Re: 121-129 York St./Harborview Townhouses

**TO: CITY OF PORTLAND PLANNING AUTHORITY**  
**DATE: APRIL 14, 2011**  
**RE: REPLY TO LEVEL III SITE PLAN REVIEW COMMENTS DATED**  
**APRIL 12, 2011**

Subject: 127 – 129 York St.  
Owner Applicant: Harborview Development LLC

Subject: 127 York Street – Harborview Townhouses – 044-A-4 & 5 - #2011-214  
 Response to City Zoning Comments – dated 4/12/11

TITLE:  
**PRELIMINARY SITE PLAN**  
(NOT FOR CONSTRUCTION)

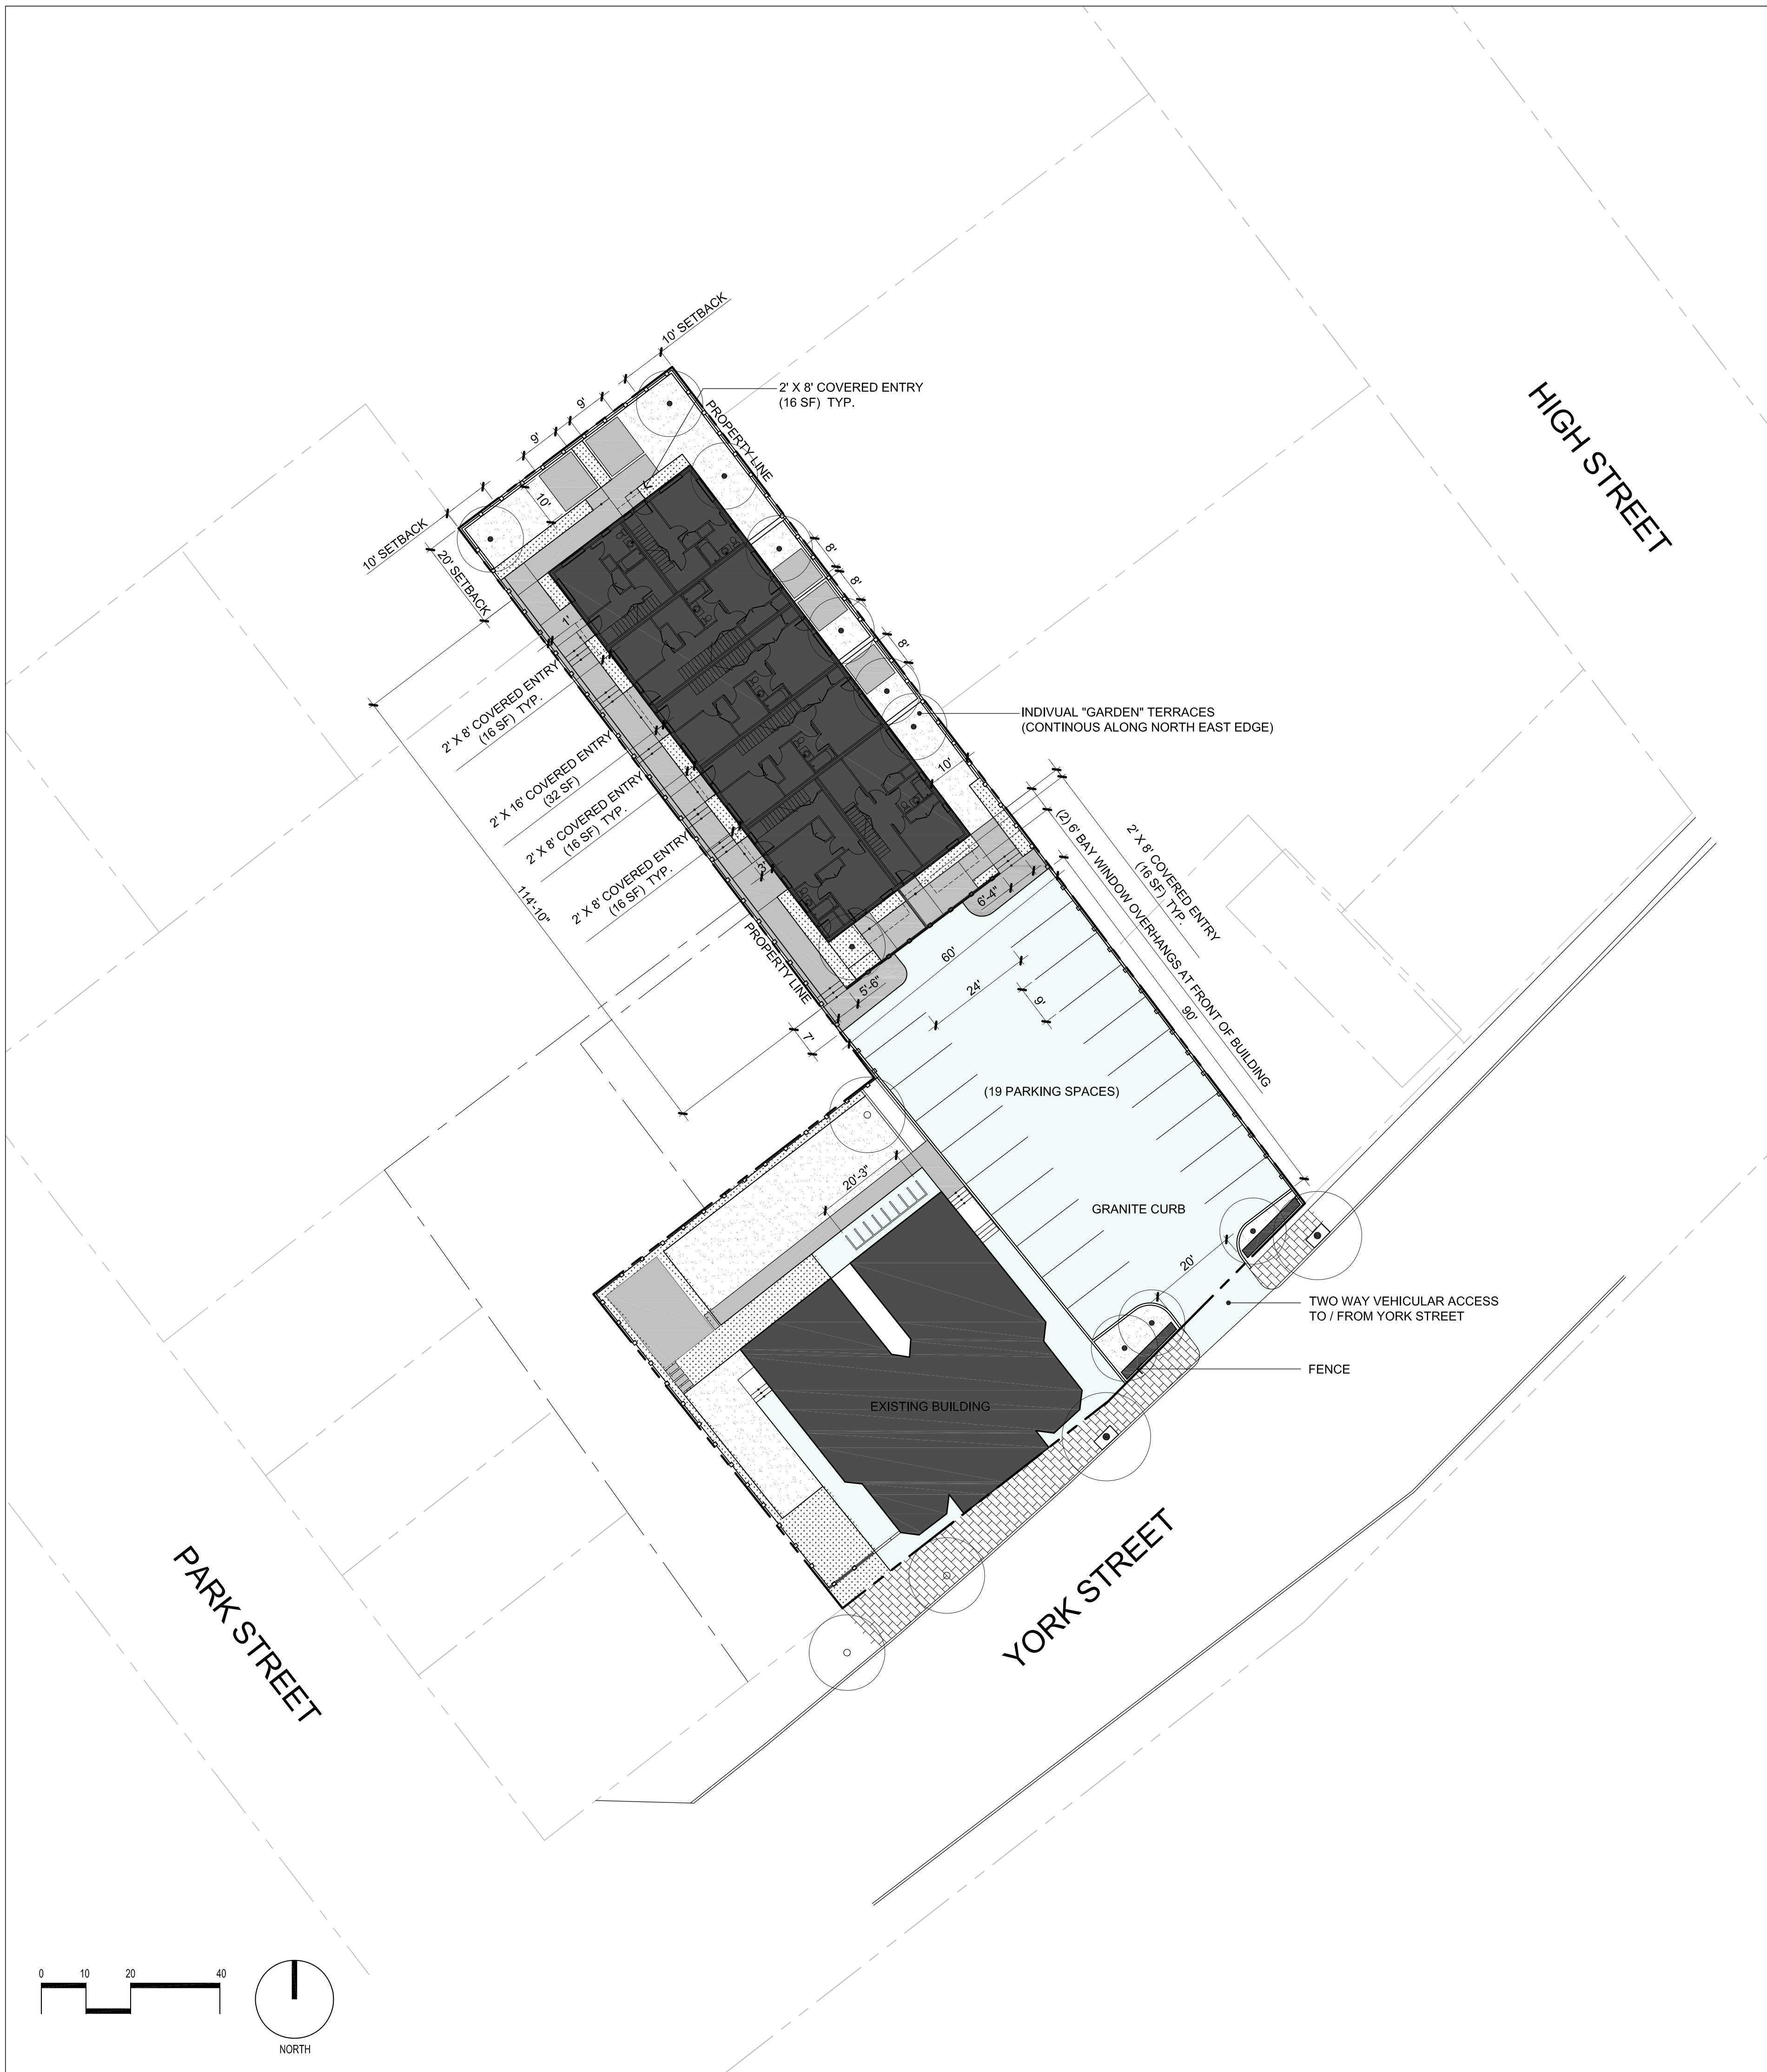
5. I am not sure that all overhangs and projections have been shown on the building site plan.

6. I am not sure what all the markings around the building refer to.

7. I am also seeing a mention on the plans that two signs on either side of the driveway would be proposed. Two signs would not be allowed and not within 5’ of the property line for site line purposes. Sign permits are a separate application, but I don’t mind reviewing the concepts at this stage.

See the revised Site Plan.

See the revised Site Plan – markings are explained in the Symbols Legend.

See the revised Site Plan. These are street fences with the property address on one of them, not signs.
